DEVELOPMENT APPLICATION ASSESSMENT REPORT

Application Number:	DA2021/1810
----------------------------	-------------

Responsible Officer:	Thomas Burns
Land to be developed (Address):	Lot 25 DP 16029, 49 Grandview Drive NEWPORT NSW 2106
Proposed Development:	Alterations and additions to a dwelling house
Zoning:	E4 Environmental Living
Development Permissible:	Yes
Existing Use Rights:	No
Consent Authority:	Northern Beaches Council
Land and Environment Court Action:	No
Owner:	Benjamin Scott Weatherall Mariela Sanchez Cana
Applicant:	Benjamin Scott Weatherall

Figure 1: Height of the proposed development relative to the natural ground level

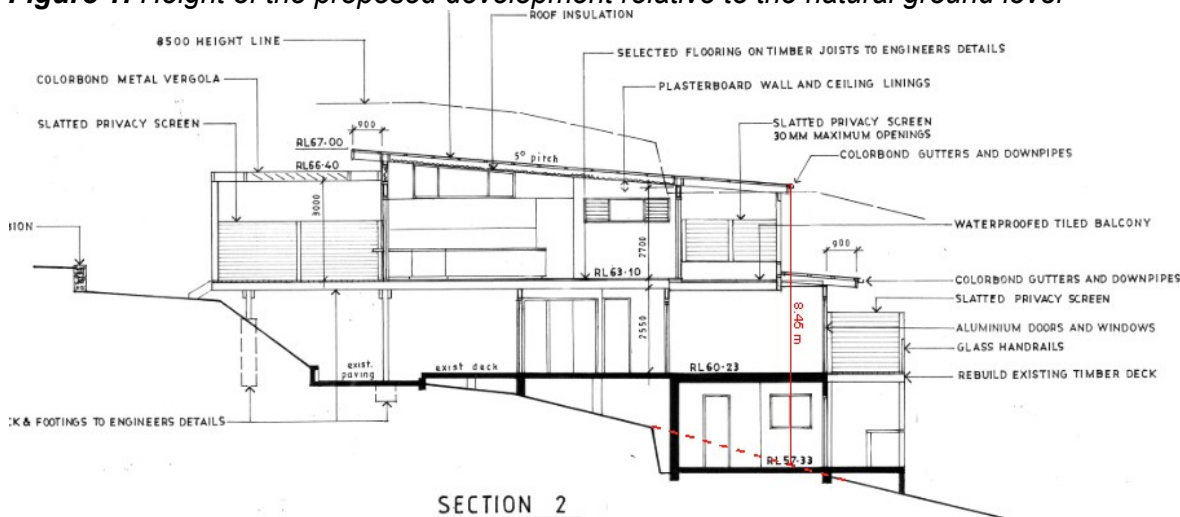
The documentation submitted with this application stipulates that the maximum building height of the upper floor addition is 8.9m, which exceeds the 8.5m statutory height limit. In calculating the building height, the applicant referred to the vertical distance between the roofline and the finished floor level of the lower ground floor, which has been excavated below the natural ground level of the site.

When considering what constitutes the existing ground level, it is noted that the existing ground level should be taken from the levels of an undisturbed site, rather than an excavation point below the natural ground line. This is often referred to as the extrapolated ground line.

When calculating the maximum building height relative to the extrapolated ground level, the maximum building height is 8.45m, which complies with the 8.5m height of buildings development standard. Figure 1 below depicts height of the structure in relation to the existing (extrapolated) ground level.
